Re: Permit No. M-1980-244; Cripple Creek & Victor Gold Mining Company; Cresson Project; Adequacy Review Response to Technical Revision 128 – Ironclad Facilities Access Road Re-Alignment

**ATTACHMENT 1:
PROPOSED ACCESS ROAD & NON-
JURISDICTIONAL WETLANDS MAP**

Proposed Access Road & Non-Jurisdictional
Wetlands Map

Table 2. Summary of analysis results

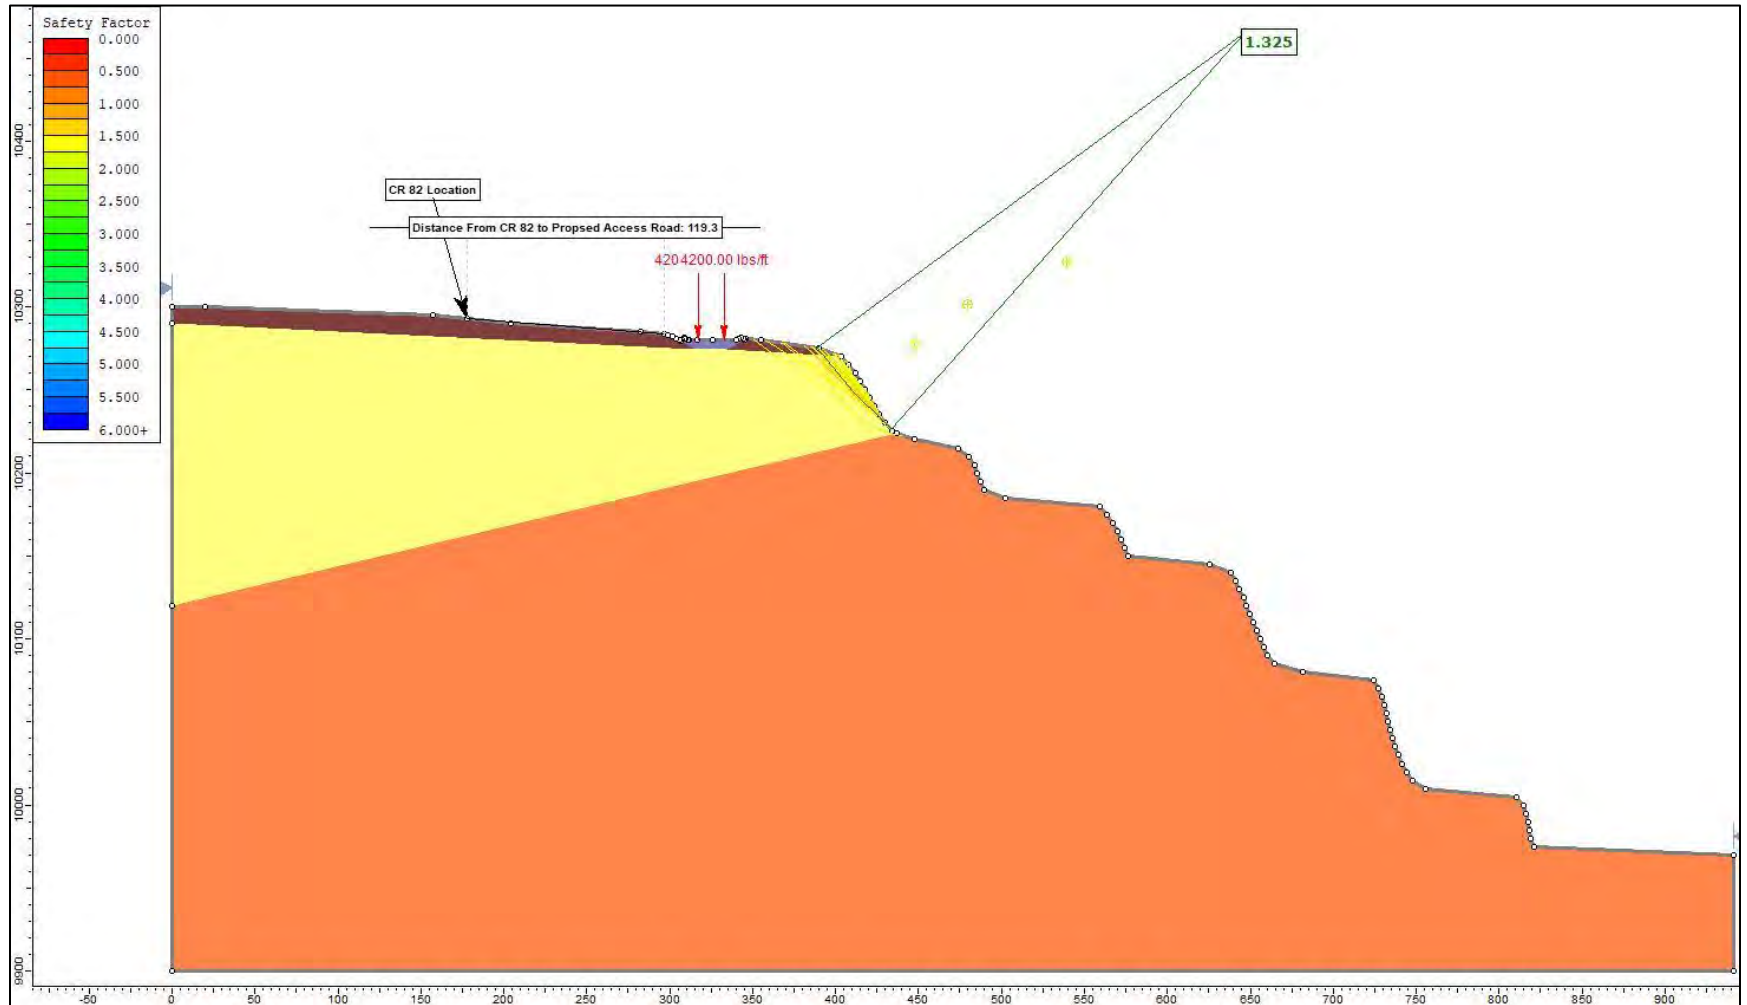
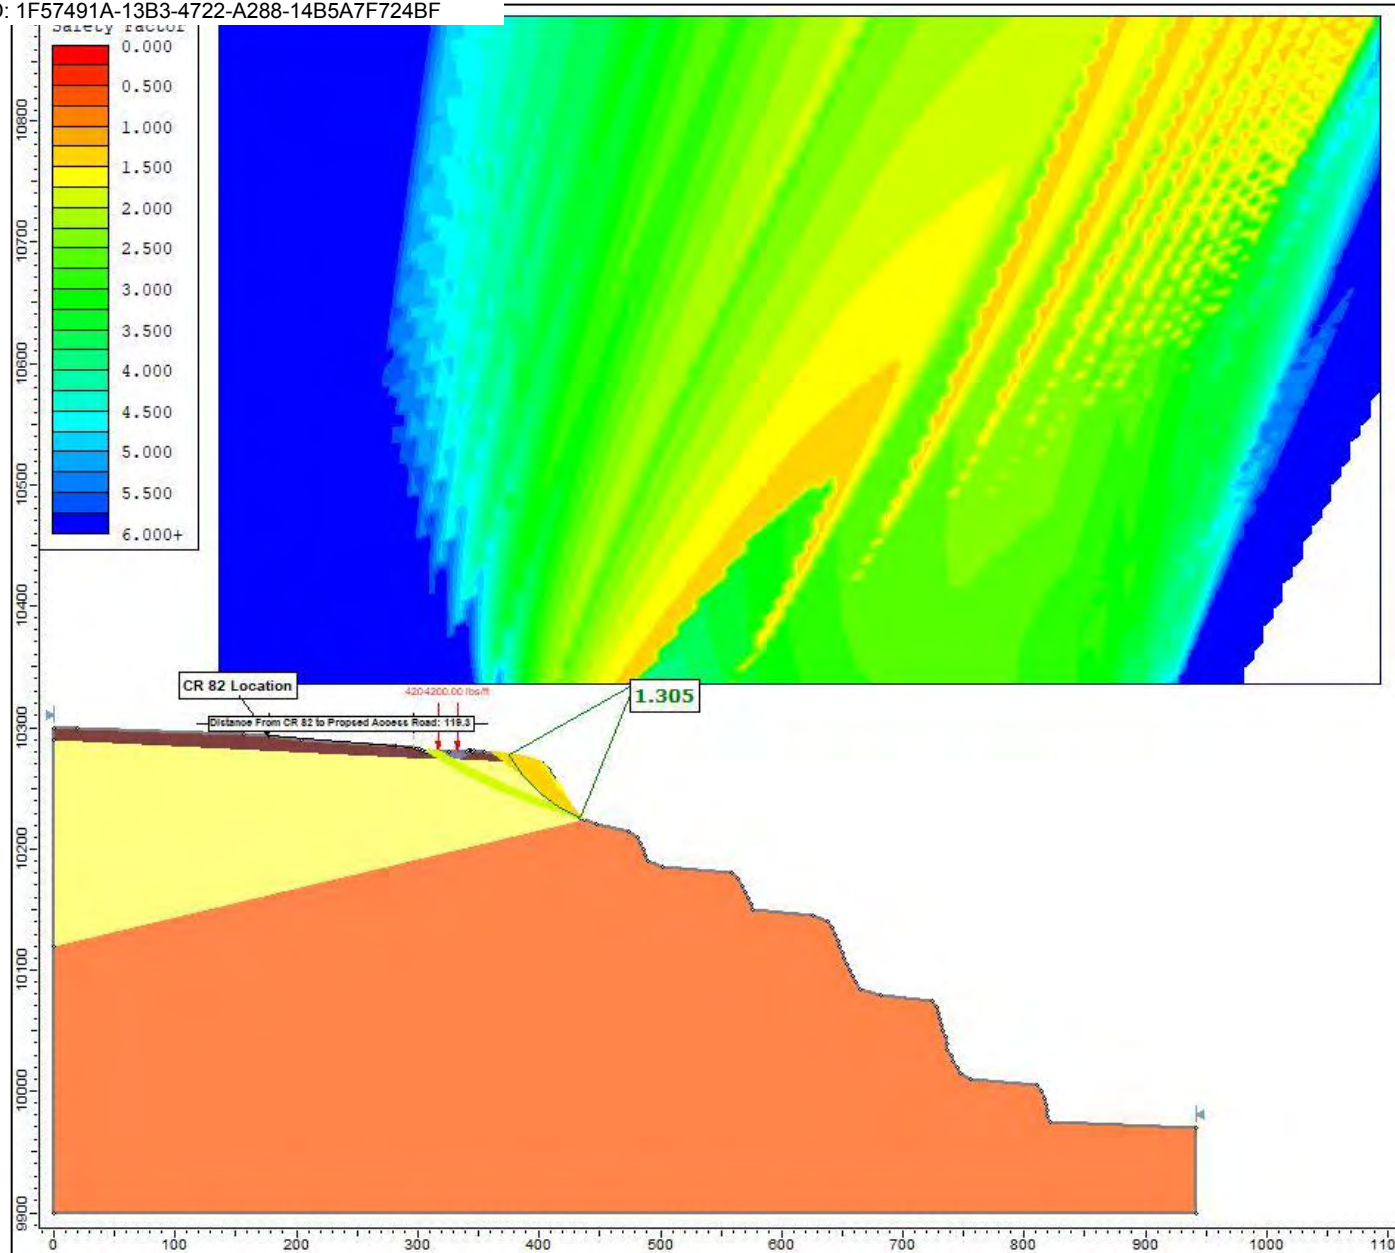
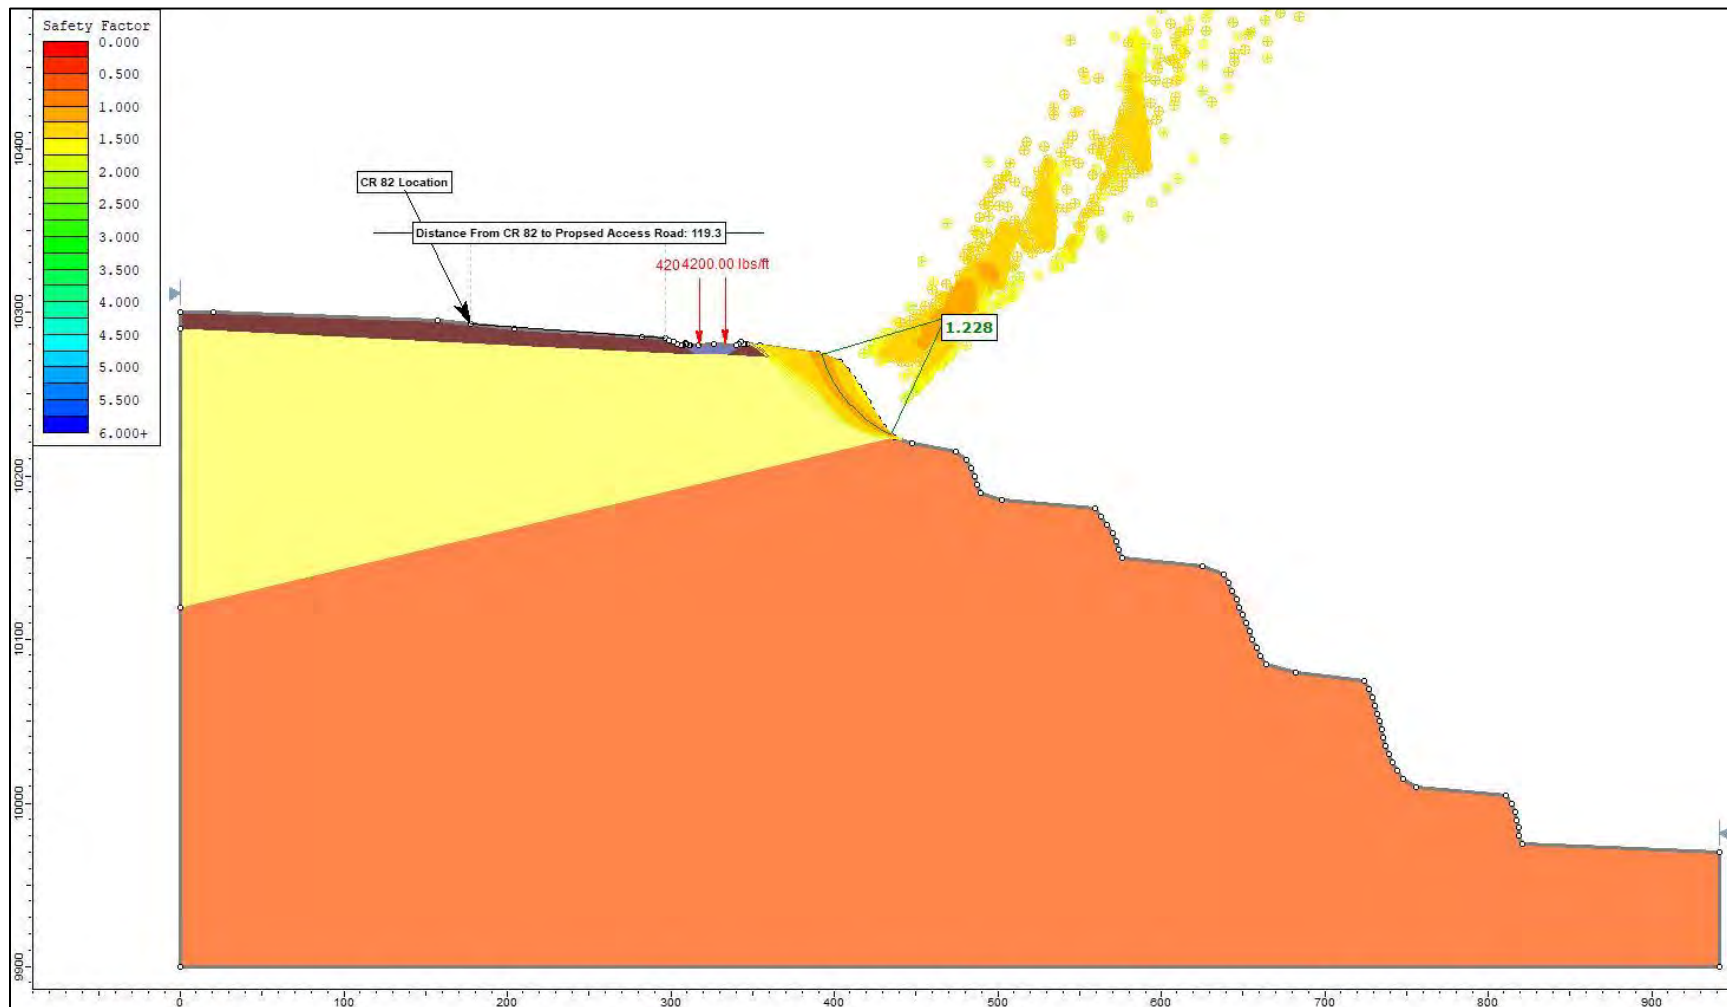
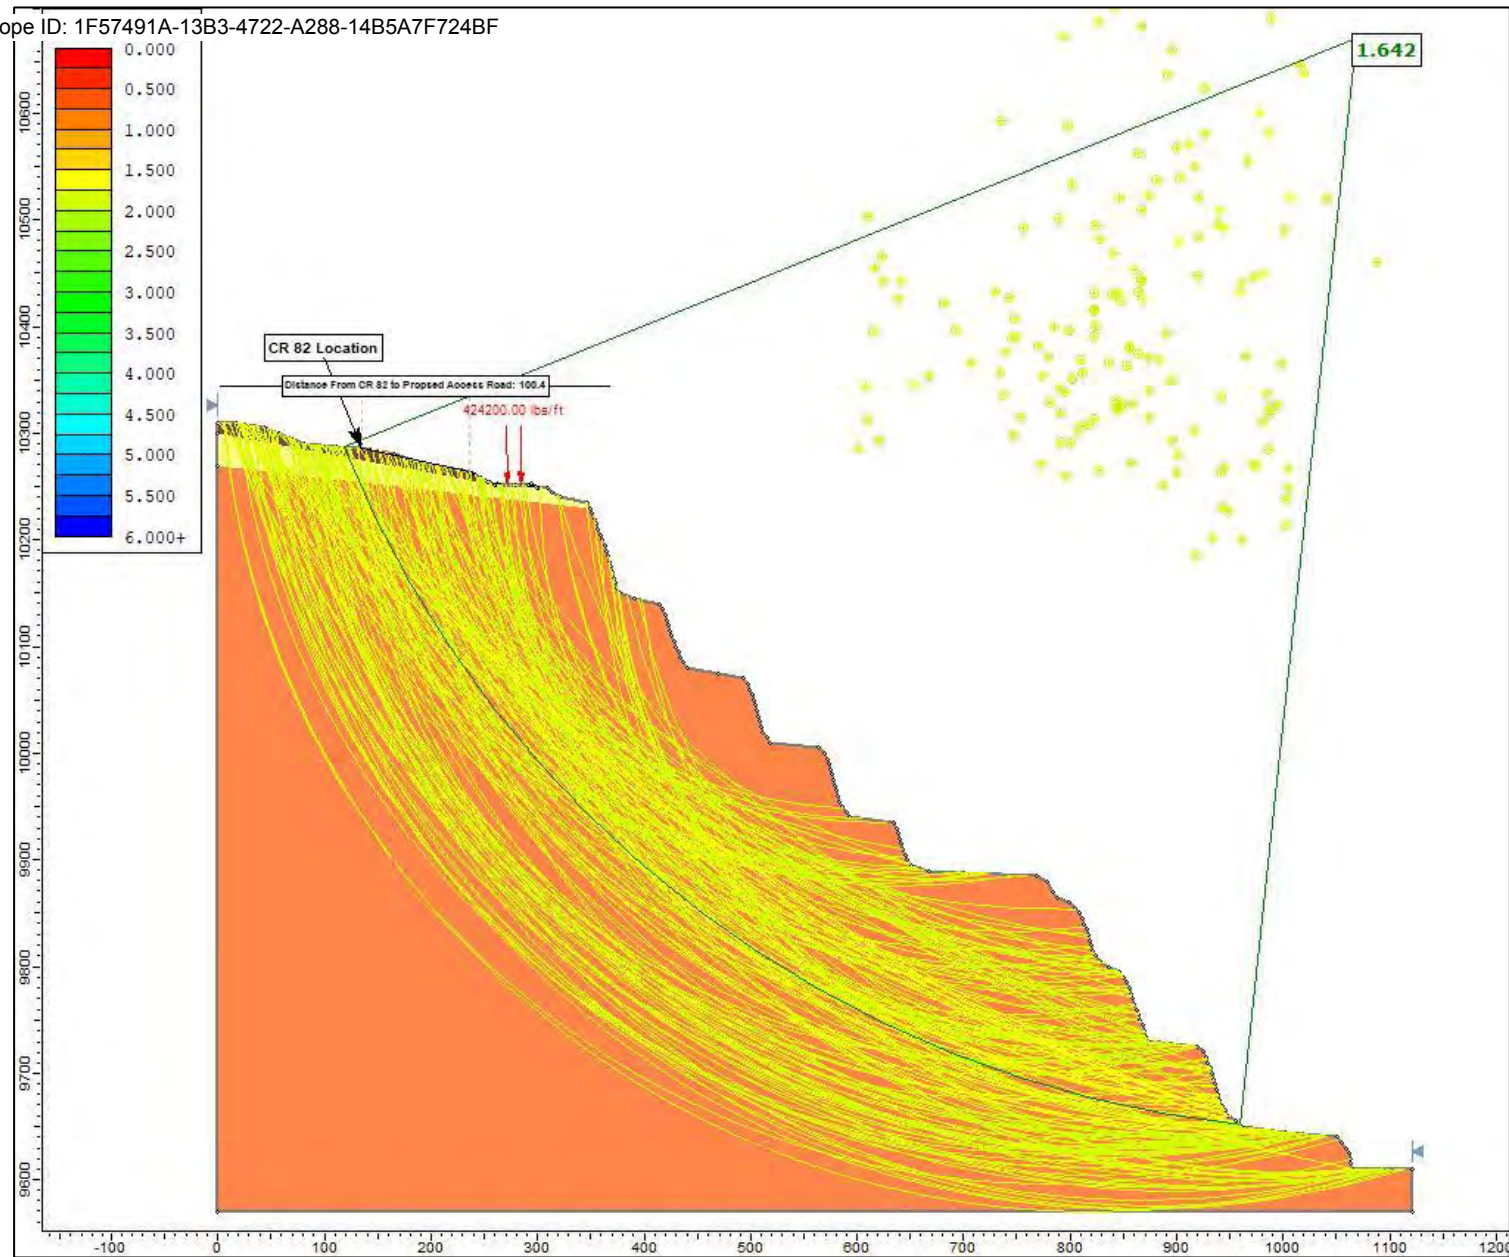
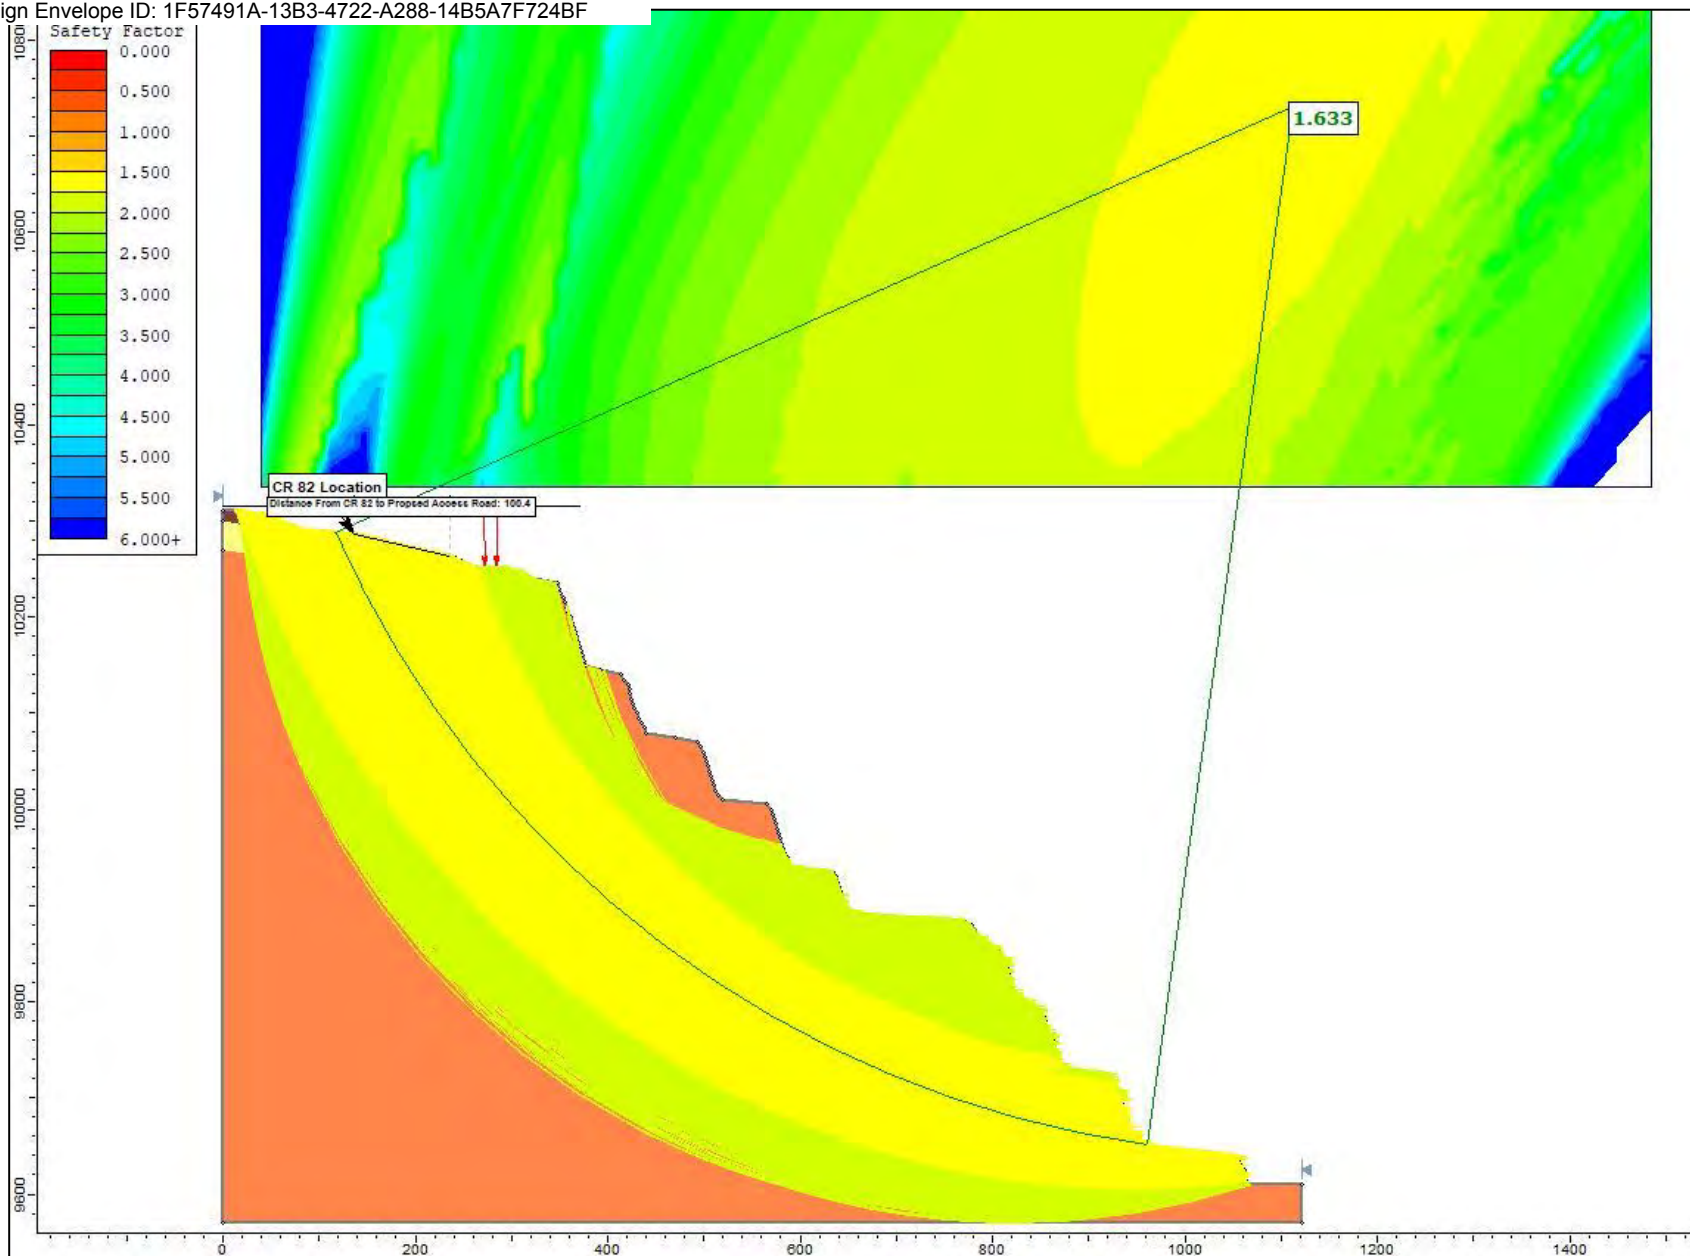
- 9. Please submit a geotechnical stability analysis showing the addition of the road along the crest of the WHEX Pit highwalls does not affect the stability of the highwalls. The analysis will need to specifically cover the portions of the road from Station 2+00 to 10+00 and 32+00 to 42+00. The analyses should account for two simultaneously passing semi-trucks (H-20 loading) within these designated sections of the proposed road.**

Cross Section #	Analysis Method	FoS	
Section 1	Grid Analysis	1.305	Average
	Slope Search	1.228	1.286
	Auto-refine Search	1.325	
Section 2	Grid Analysis	1.633	Average
	Slope Search	1.642	1.634
	Auto-refine Search	1.628	
Section 3	Grid Analysis	1.211	Average
	Slope Search	1.155	1.167
	Auto-refine Search	1.135

The analysis showed that the location of the proposed haul road, as well as the loading from delivery trucks, does not affect the stability of the highwalls. The standard for the minimal FoS for this analysis is defined in the revised policies Mined Land Reclamation Board (MLRB). Section 30.3 and 30.4 of the MLRB revised policies outlines the guidance for minimum FoS standard of 1.3 for construction slopes near roadways and utilities. Cross Section 2, average FoS of 1.634 is higher than the minimum allowable FoS of 1.3 (see Appendices 4-6) Cross sections 1 and 3 show an average FoS of 1.286 and 1.167 respectively (See Appendices 1-3 and 7-9). These FoS are below the minimum of 1.3, however the surfaces that display these minimums represent smaller, superficial instability rather than global slope instability. For both Cross Sections 1 and 3, the minimum FoS values can be attributed to the weaker material properties assigned to the Valley Fill and Weathered Breccia materials. This failure type is consistent with current field conditions and is being managed and monitored by the CC&V Geotechnical group. Monitoring of the ground conditions during the construction of the proposed access road will be undertaken by CC&V Mine Operations and Mine Technical Services. Additional geotechnical monitoring will be installed to ensure the long-term stability of the proposed access road re-alignment.
